Independent Assessment Report

Section 4.56 Application: 12A and 14-26 Wattle Street, Pyrmont - D/2019/649/B**File No.:** D/2019/649/B**Summary**

Figure 14: Envelope plans: Approved and proposed 3D massing West

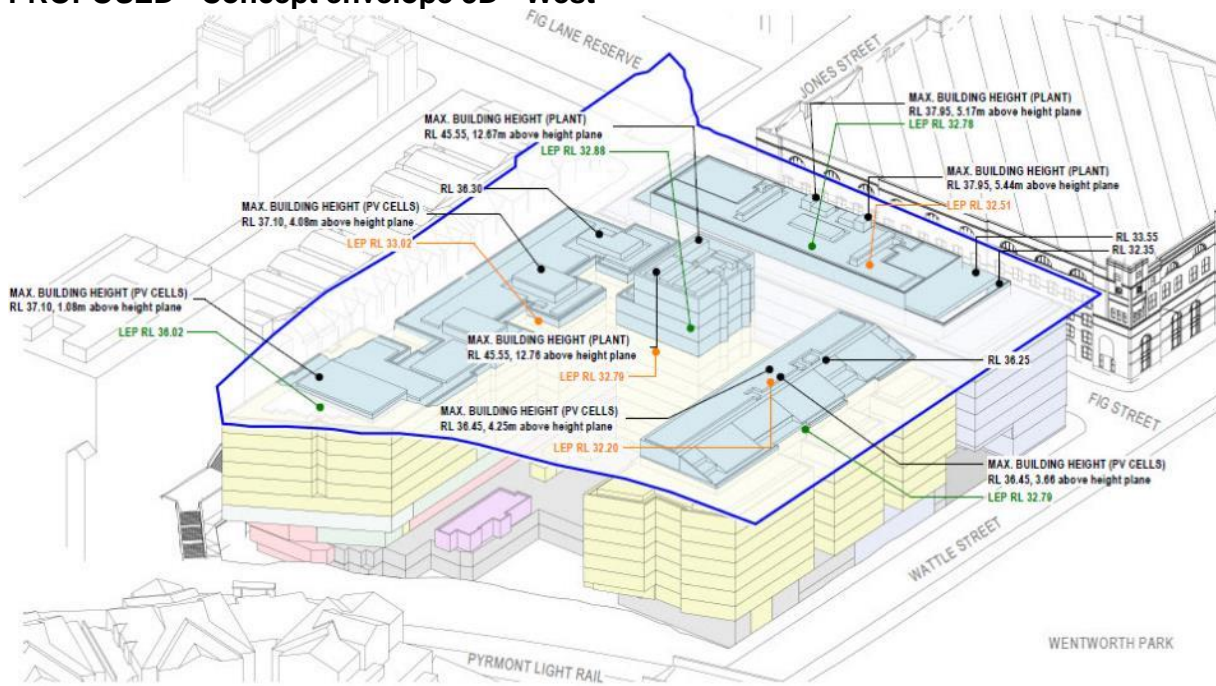
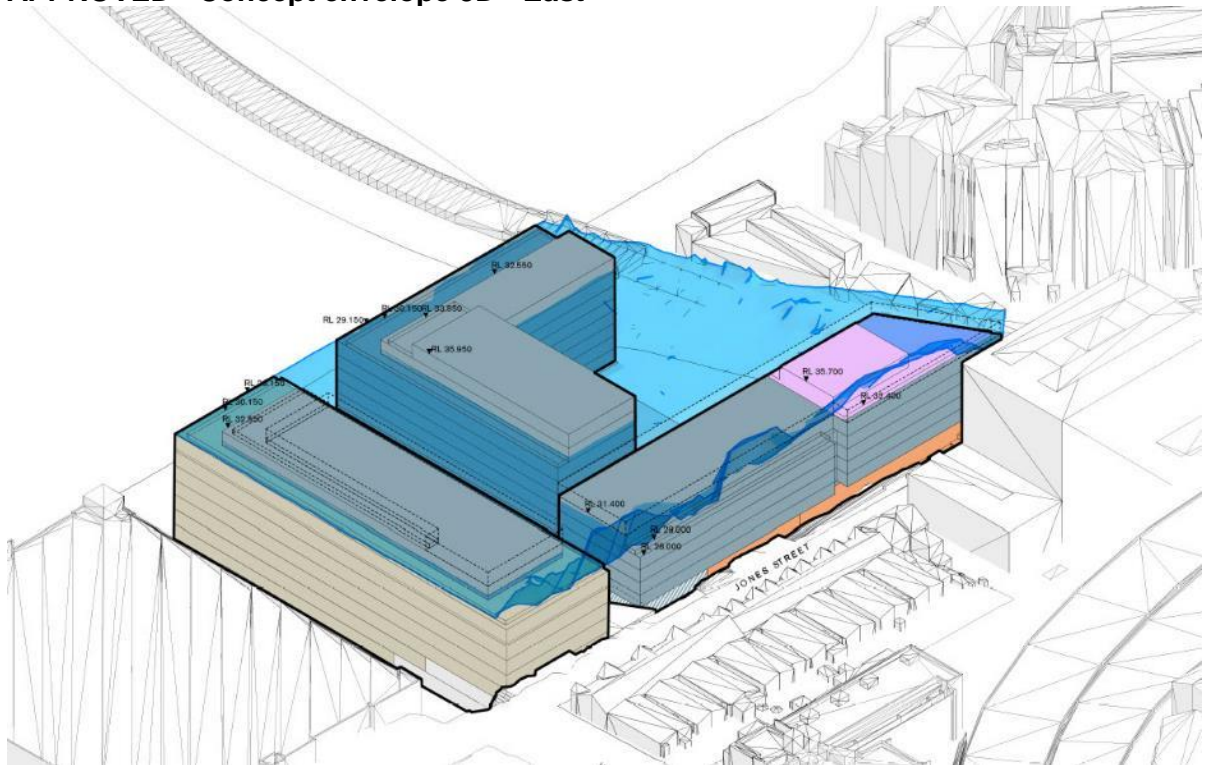
- (i) The concept consent approved an "L" shaped Wattle Street Building (see (see **Figures 14** and **15**). The section 4.56 modification application splits the approved "L" shaped envelope into Building D - Wattle Building (considered below) and Building C - Courtyard (considered here).

Figure 35: Section 4.56 modification application: Isometric drawing showing non-compliance with the 27m height standard permitted by clause 4.3 of Sydney LEP 2012 (western view)

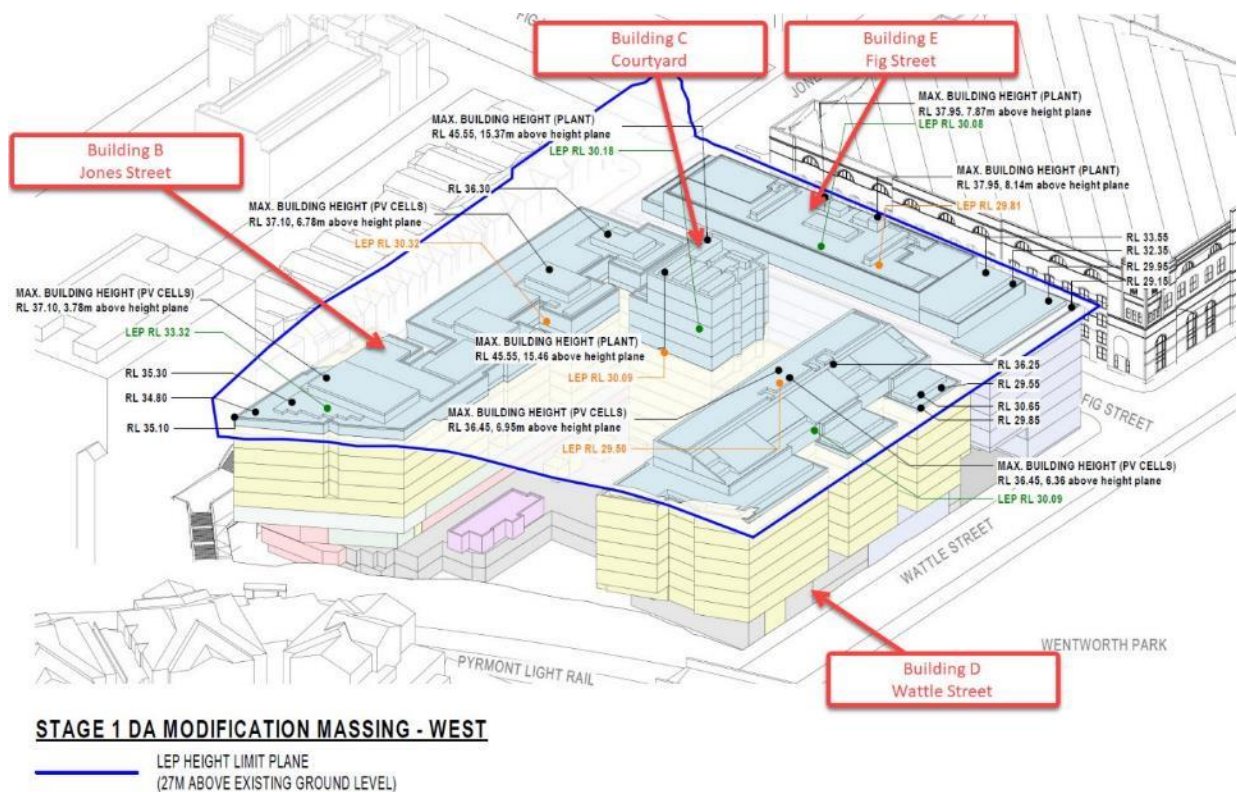
52. **Figures 35 and 36** illustrate the height non-compliances of the concept consent and section 4.56 modification application (noting the name of each building). The winning scheme also exceeded the 29.7m height permitted by clause 6.21D height (see **Figure 37**).

Figure 38: Building B - Jones Street Section: Proposed/modified building envelope

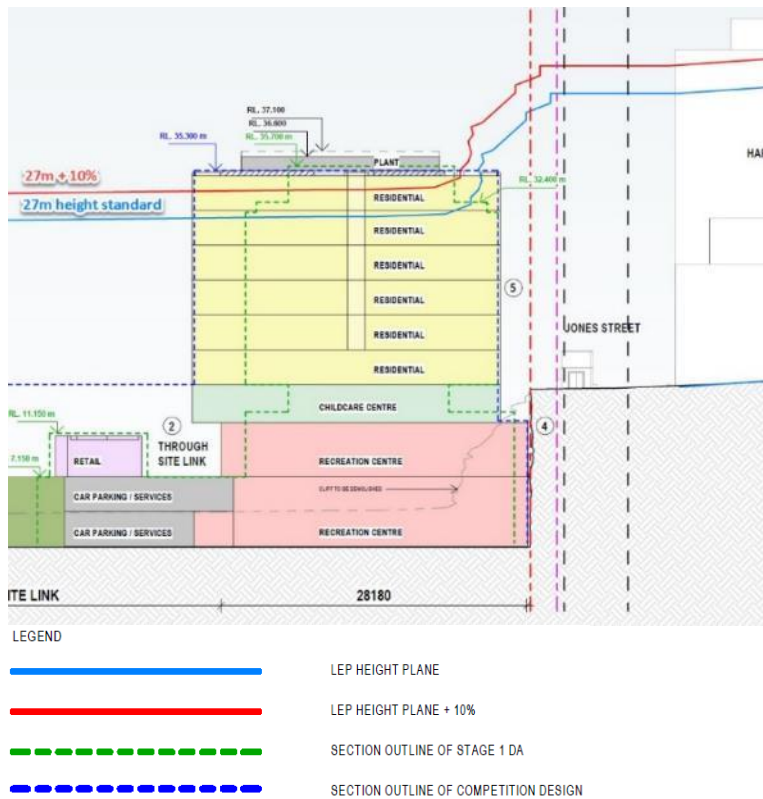
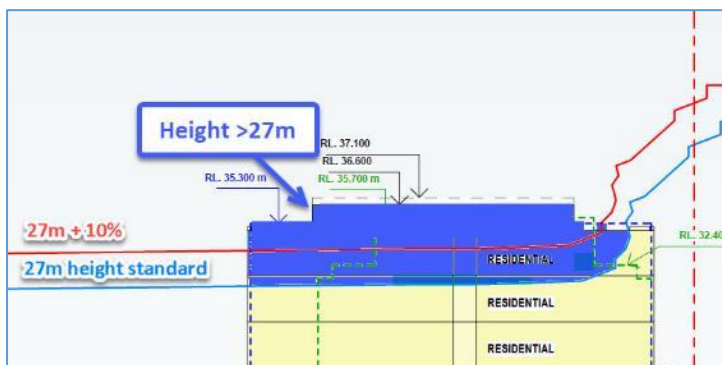
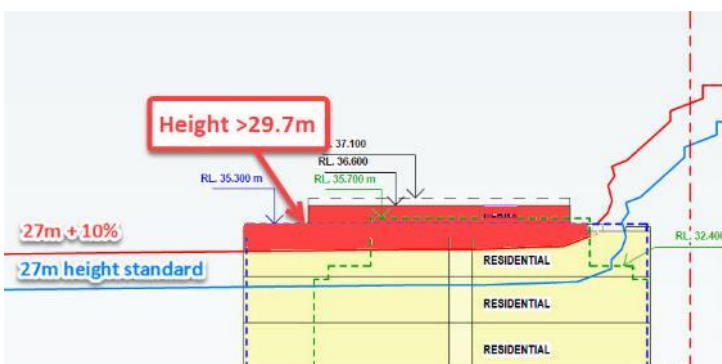
- (ii) The section 4.56 modification application proposes six storeys (residential) above Jones Street for Building B - Jones Street (see **Figure 38**).

- (iii) The proposed/modified envelope for Building B - Jones Street exceeds the 27m height standard height permitted by clause 4.3 of Sydney LEP 2012 by up to 6.78m (+25%). The proposed height above 27m is illustrated in section on **Figure 39**.

- (iv) The proposed/modified envelope for Building B - Jones Street exceeds the 29.7m permitted by clause 6.21D of Sydney LEP 2012 by up to 4.08m (+14%). Measured to the residential roof, the Jones Building exceeds the 29.7m permitted by clause 6.21D of Sydney LEP 2012 by 1.2m (+4%). The proposed height above 29.7m is illustrated in section on **Figure 40**.

Figure 41: Building B - Jones Street: Shadow diagram at 3pm in midwinter

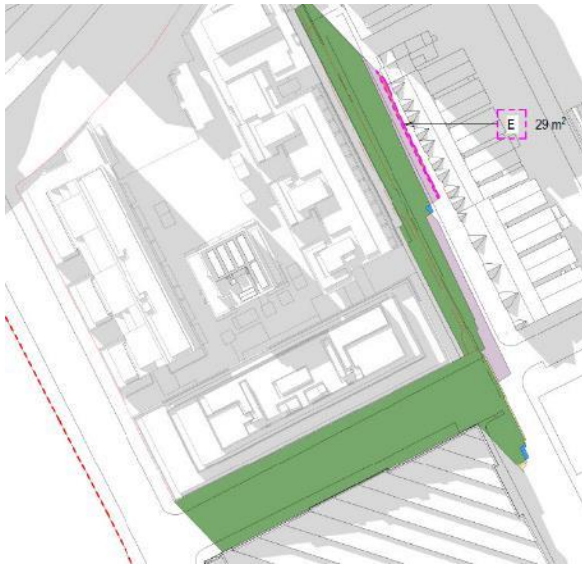
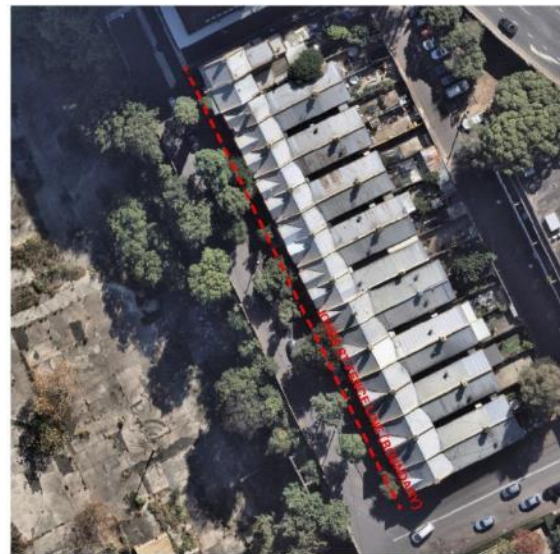
- (iv) The applicant has submitted a solar impact analysis (included at **Attachment B**) assessing the overshadowing impact of the proposed/modified envelopes highlighting the additional shadow cast by the modification application beyond the building envelopes approved by the concept consent. The analysis shows that the additional height on Building B - Jones Street will overshadow the roadway of Jones Street and for a short time and the front yard of several Jones Street terraces (29m² at 3pm in midwinter, Labelled with an "E" on **Figure 41**). An assessment of compliance with the relevant solar access controls in Sydney DCP 2012 follows:

- (v) Compared with the building envelope plans approved by the concept consent and a compliant building height, the additional height for Building B - Jones Street proposed by the section 4.56 modification application would have a negligible impact on outlook from the communal open space and dwellings in the Harbour Mill Apartments and the terrace houses on Jones Street.

Figure 42: Building C - Courtyard Section: Proposed/modified building envelope

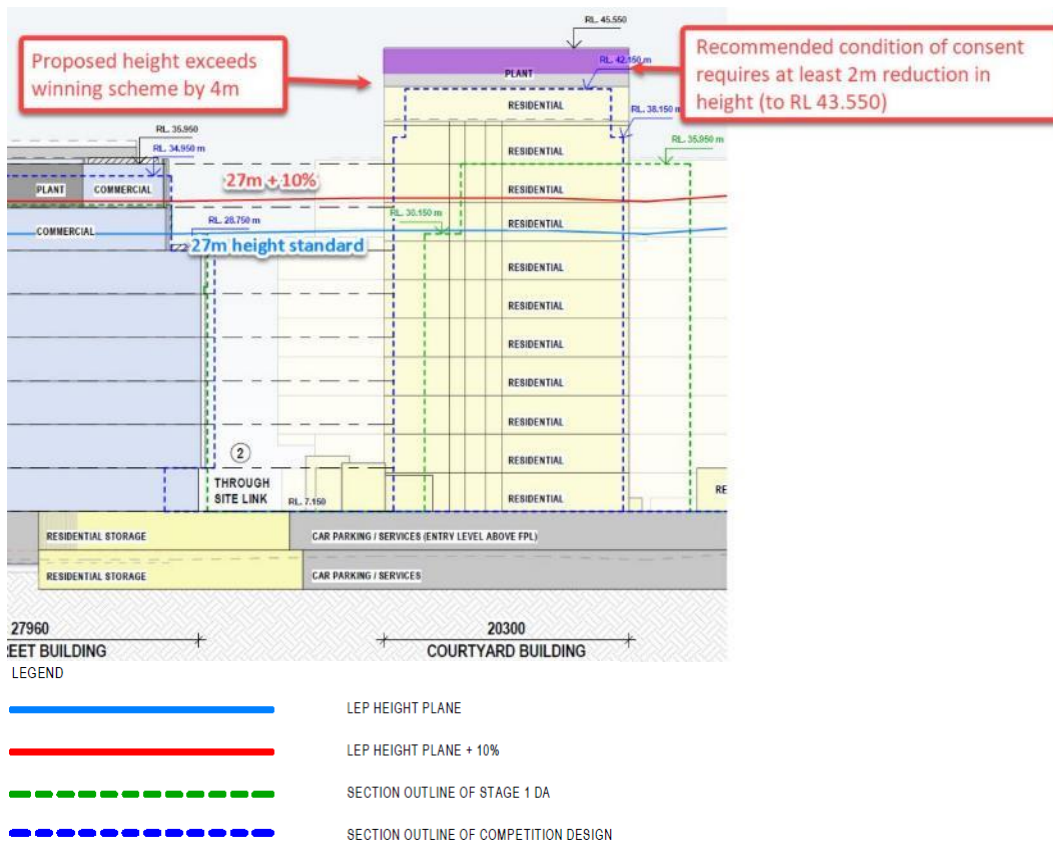
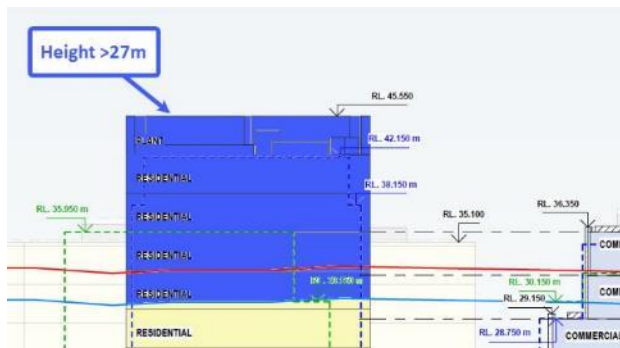
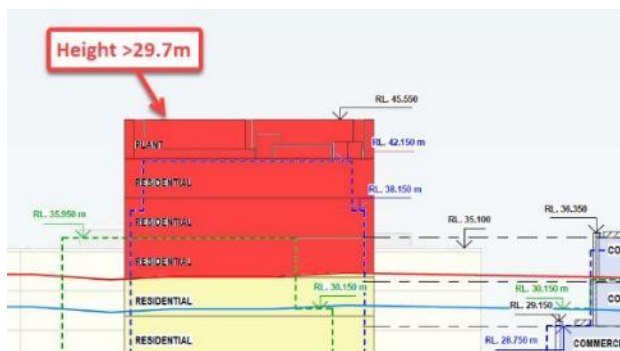
- (iii) The proposed/modified envelope for Building C - Courtyard exceeds the 27m height standard height permitted by clause 4.3 of Sydney LEP 2012 by up to 15.46m (+57%). The proposed height above 27m is illustrated in section on **Figures 42** and **43**.

- (iv) The proposed/modified envelope for Building C - Courtyard exceeds the 29.7m permitted by clause 6.21D of Sydney LEP 2012 by up to 12.76m (+43%). The proposed height above 29.7m is illustrated in section on **Figures 42** and **44**.

- (i) The Plant Room Equipment and Parapet Zone height (and any other structures at Level 13 of Building C – Courtyard) is to be reduced by at least 2m (to a maximum of RL 43.55 (AHD)).**
- (b) A new footpath and street tree planting along the site's frontage to Jones Street, as required by condition 12 below.
- (c) Areas nominated as deep soil zones must be designed as actual deep soil throughout the competitive design process and detailed design development application. Deep soil zones must be unencumbered by built elements above and below. This include basements, through site links and other paved areas
- (d) Tree planting must be able to provide a minimum of 15% canopy cover across the site within 10 years of completion.

Figure 45: Building C - Wattle Street Section: Proposed/modified building envelope

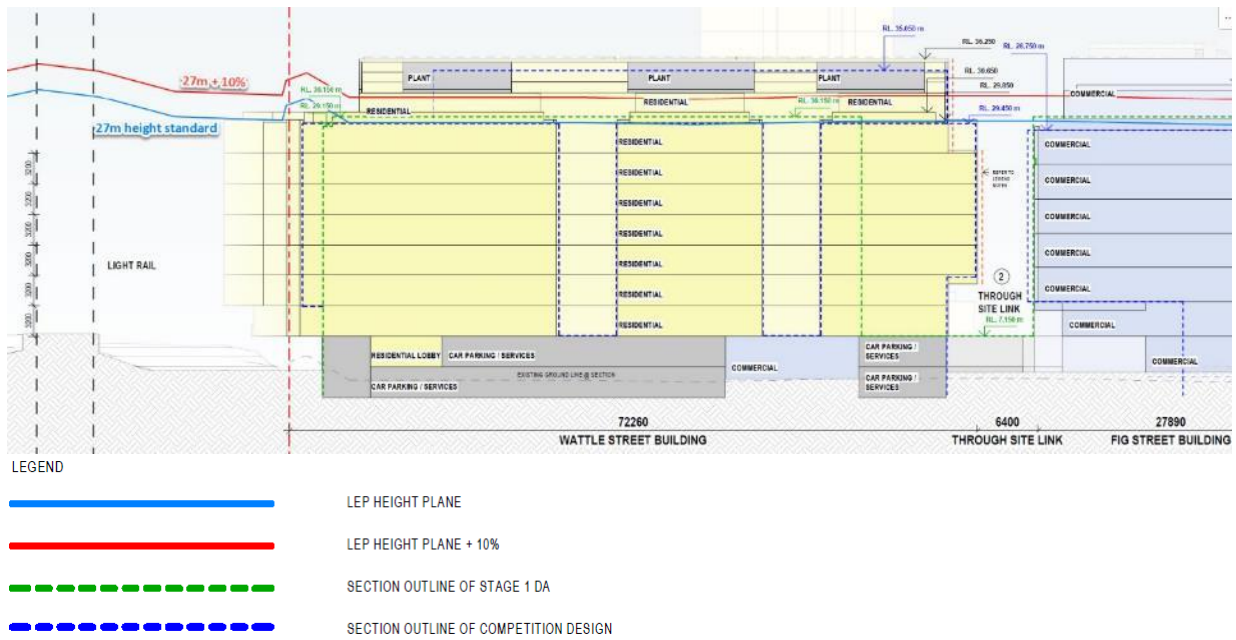
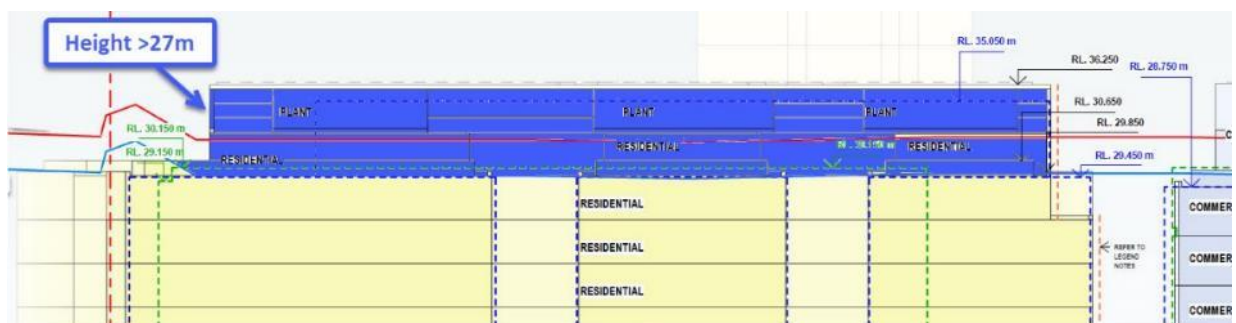
- (iii) The proposed/modified envelope for Building D - Wattle Street exceeds the 27m height standard height permitted by clause 4.3 of Sydney LEP 2012 by up to 6.95m (+26%). The proposed height above 27m is illustrated in section on **Figures 45** and **46**.

- (iv) The proposed/modified envelope for Building D - Wattle Street exceeds the 29.7m permitted by clause 6.21D of Sydney LEP 2012 by up to 4.35m (+14%). The proposed height above 29.7m is illustrated in section on **Figures 45** and **47**.

Figure 49: Building E - Fig Street Section: Proposed/modified building envelope

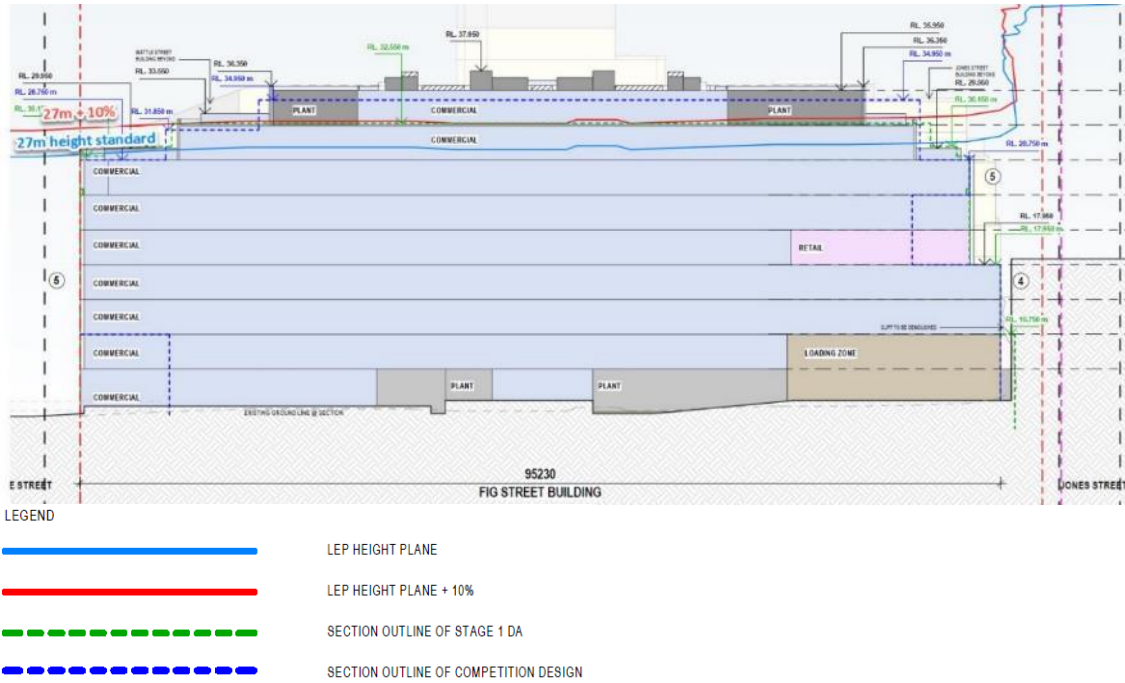
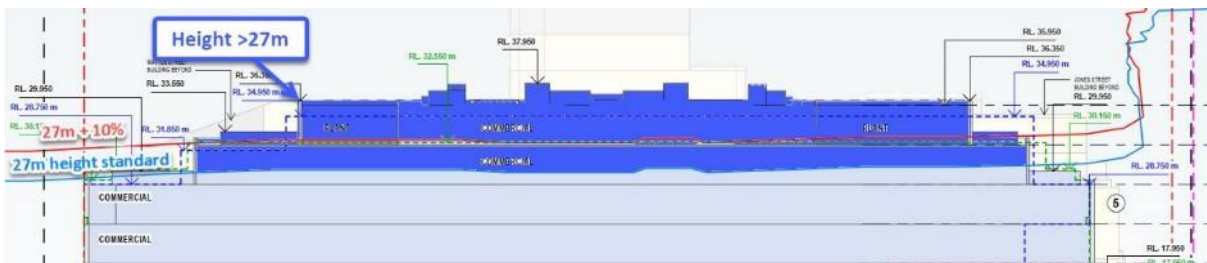
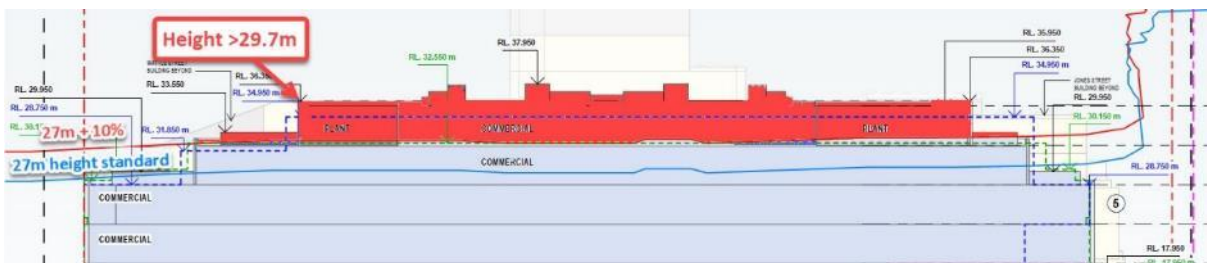
- (i) The concept consent specifies maximum RLs for Building E - Fig Street which equate to eight storeys (seven commercial storeys plus one residential storey at the top of the building). As shown by **Table 3**, the approved Fig Street Building envelope exceeded the 27m height standard by up to 3.55m (+13%). As noted in **Table 3**, the concept consent conditions provide for up to 10% uplift in building height on the Fig Street Building.
- (ii) The section 4.56 modification application proposes nine storeys for Building E - Fig Street (all commercial) (see **Figure 49**).

- (iii) The proposed/modified envelope for Building E - Fig Street exceeds the 27m height standard height permitted by clause 4.3 of Sydney LEP 2012 by up to 8.14m (+30%). The proposed height above 27m is illustrated in section on **Figure 50**.

- (iv) The proposed/modified envelope for Building E - Fig Street exceeds the 29.7m permitted by clause 6.21D of Sydney LEP 2012 by up to 5.4m (+18%). The proposed height above 29.7m is illustrated in section on **Figure 51**.
